Plan of Operations
Palmer Advanced Exploration Project
Haines, Alaska

Amendment No. 1

MHT Upland Mining Lease No. 9100759

April 2022

Figure 3. Site Drawing Showing Major Surface Components

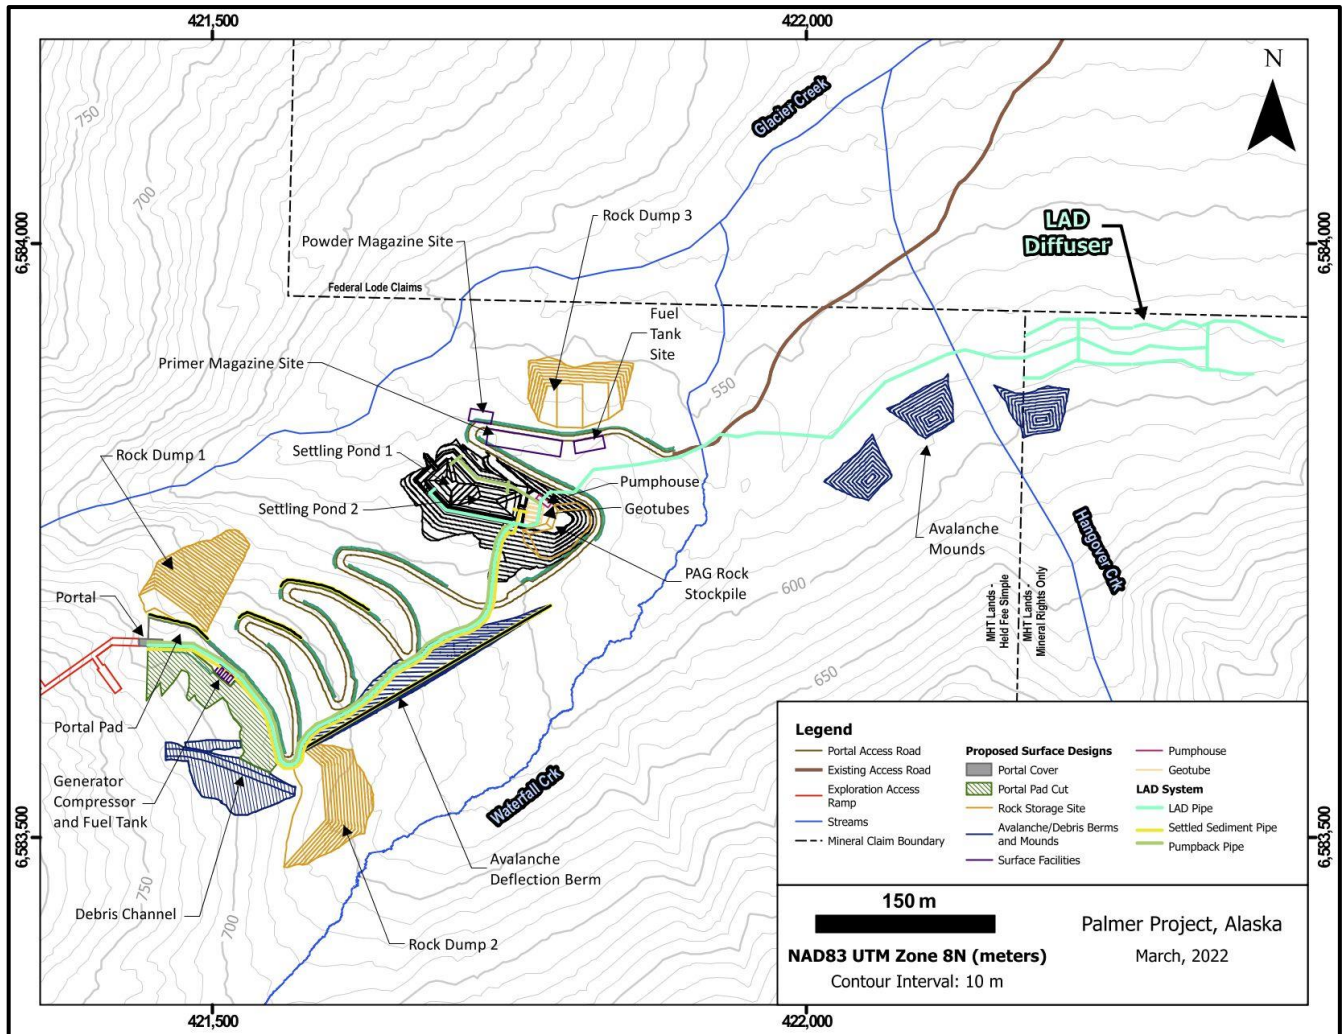
The portal access road includes a series of switchback to reach the portal site. The ground in this steep section consists largely of poorly consolidated colluvium and debris-flow material. Constantine constructed a pioneer trail following the approved road alignment to the portal site in 2018. Since that time Constantine has made minor alignment and construction method improvement to the 2018 design. The design changes improve safety and travelability on the road. These design changes also include construction of a diversion channel with berms above the upper switchback to deflect a natural debris flow (rock and soil) from impacting the road. The updated road alignment is depicted on Figure 3.

Figure 4. Conceptual Flow Diagram of the Water Treatment Plant

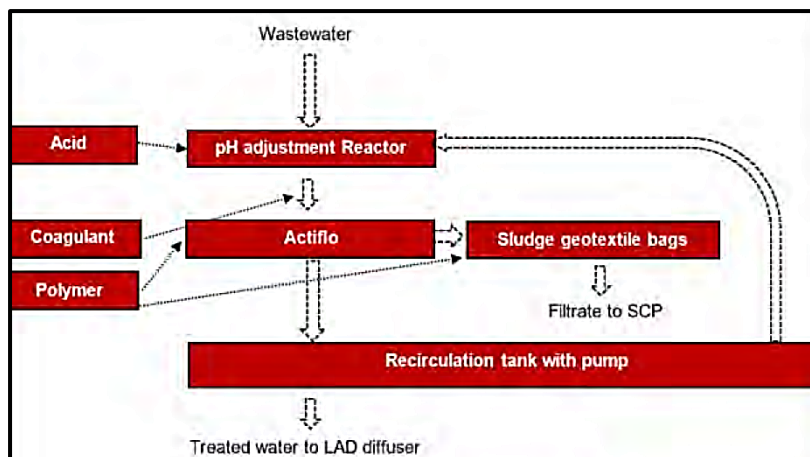
Constantine has now integrated active water treatment for settleable solids into the water management strategy and is including it in this Amendment.

Active water treatment will consist of pH adjustment, treatment with coagulant and polymer, followed by settling and clarification. The conceptual flow design of the water treatment plant is illustrated in Figure 4 (Veolia, 2022).

Figure 5. Updated Layout for Settling Pond Area

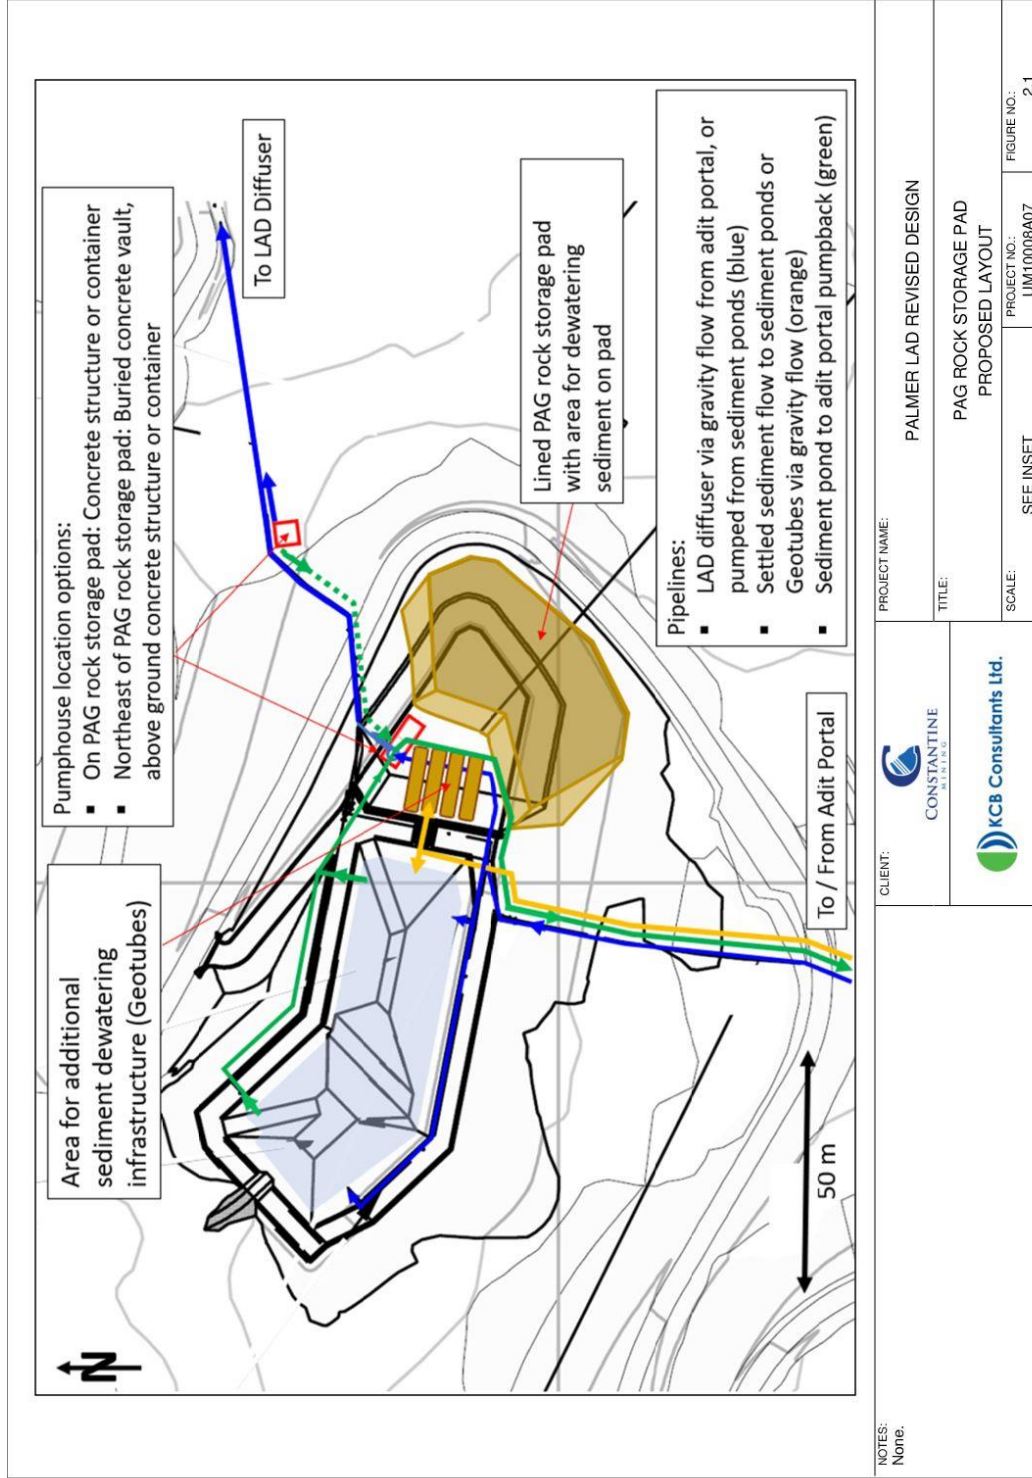
The addition of active water treatment for suspended solids at the portal reduces reliance on the ponds for solid settling and frees them for other uses. One settling pond is now designated for solid settling or storage when underground seepage flows exceed the water treatment plant capacity (not expected) or for short periods when the plant is not operating (i.e., for maintenance). The addition of a pump facility adjacent to the ponds will also allow Constantine to pump untreated water back to the treatment plant for treatment, or directly the LAD diffuser for short periods. The second pond will be used to manage inert settled solids as noted below.

The water treatment plant will separate solids and generate a stream of solids (slurry) which will be dewatered by pumping the slurry through porous geotubes positioned adjacent to the two ponds. During the summer months the slurry will be pumped directly into geotubes. In winter the slurry will be pumped and stored on one of the settling ponds and then pumped into the geotubes the following summer.

The amended layout of the settling pond area is depicted in Figure 5. The updated design of the diffuser is illustrated in Figure 6.

Figure 6. Design Drawings of LAD Diffuser

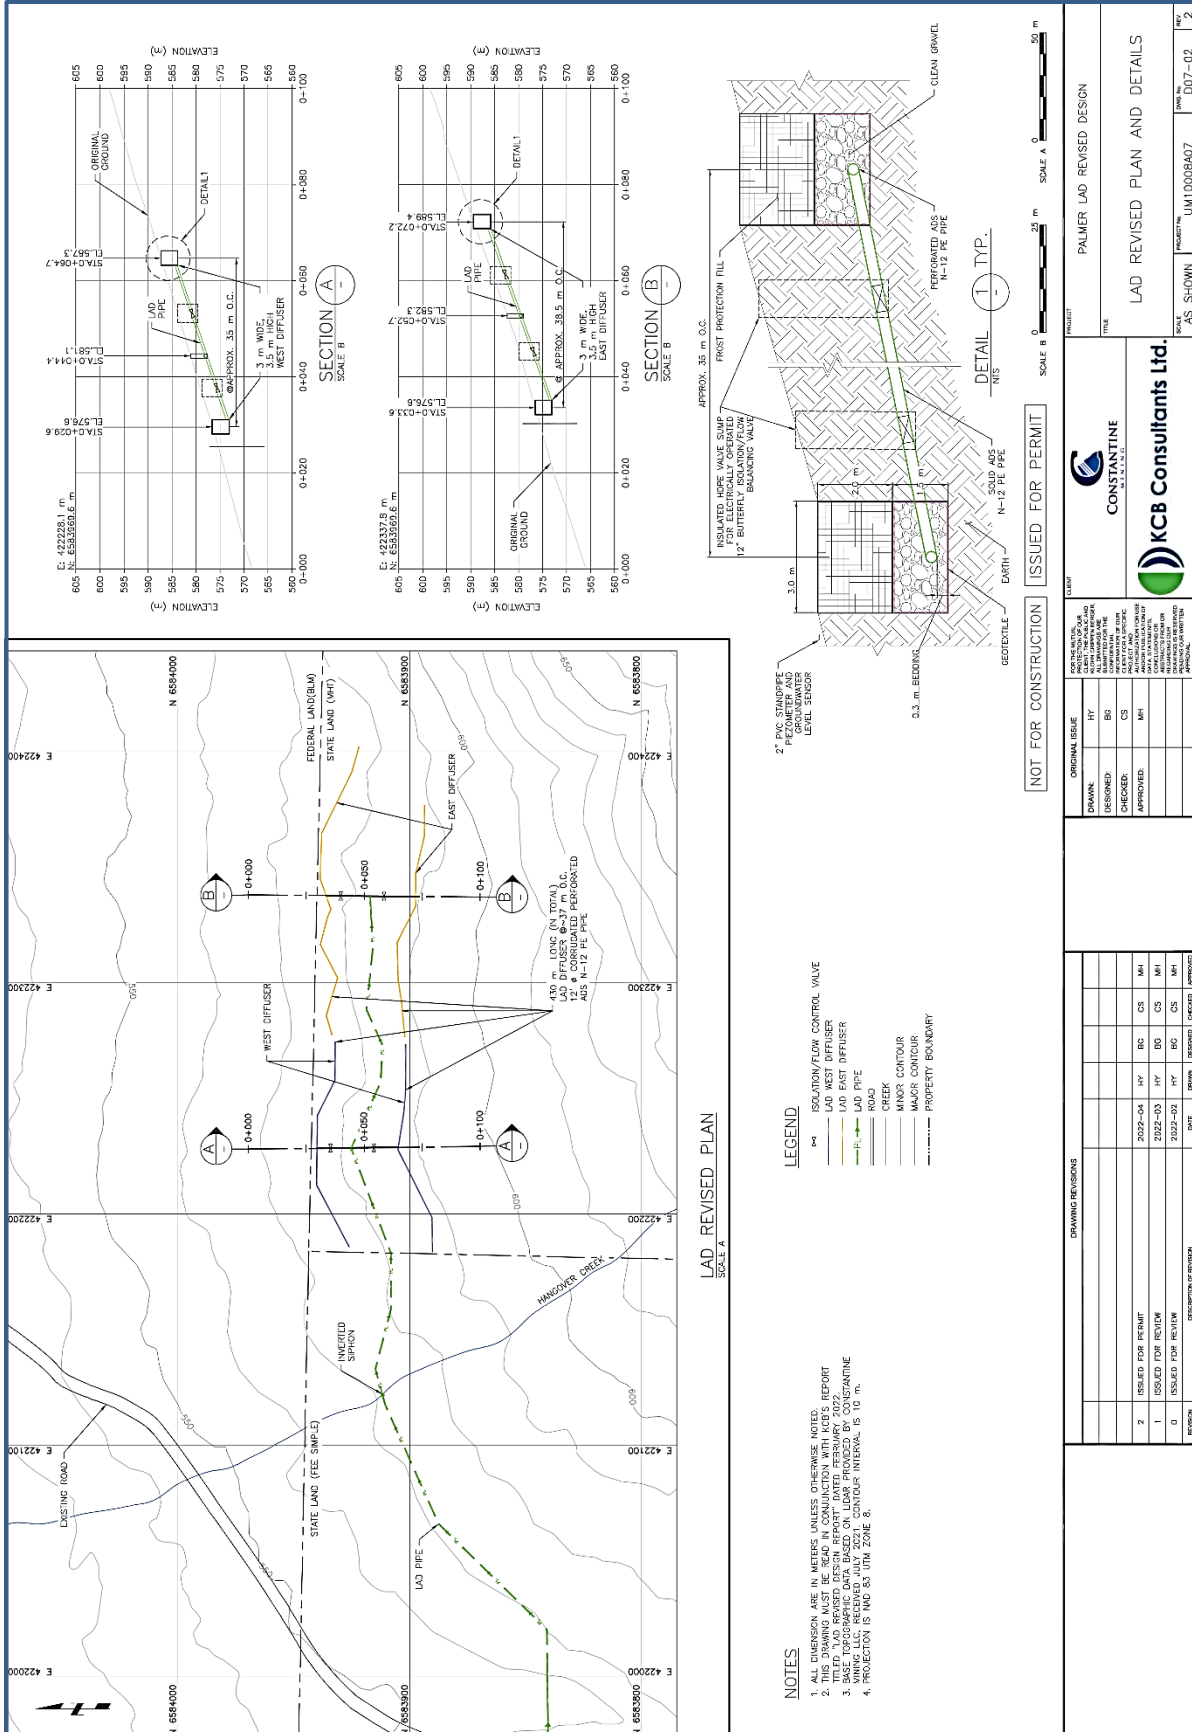
- Relocating the proposed location of the lower LAD diffuser to the northeast side of Hangover Creek and eliminating the upper diffuser from the LAD system.
- Making design modifications to the LAD diffuser pipe configuration.
- Adding an inverted siphon to the design as required to convey water across Hangover Creek to the new LAD diffuser site. There is already one inverted siphon in the LAD design to convey water across Waterfall Creek.
- Adding a pump facility adjacent to the settling ponds to the design to provide an option to pump untreated water back to the water treatment plant or the LAD diffuser.
- Repurposing the intended settling ponds so they can provide settling or storage during periods of unanticipated surplus underground seepage flow and for settled solids management.

Additional modeling of groundwater and infiltration of the discharge through the LAD diffuser indicates that two diffuser pipes will meet the design discharge criteria of 700 gpm continuously and peak flows up to 900 gpm, while the anticipated base flow will be 360 gpm. The 2019 design of the LAD consisted of three diffuser pipes; the updated design consists of two diffuser pipes (KCB, 2022b).
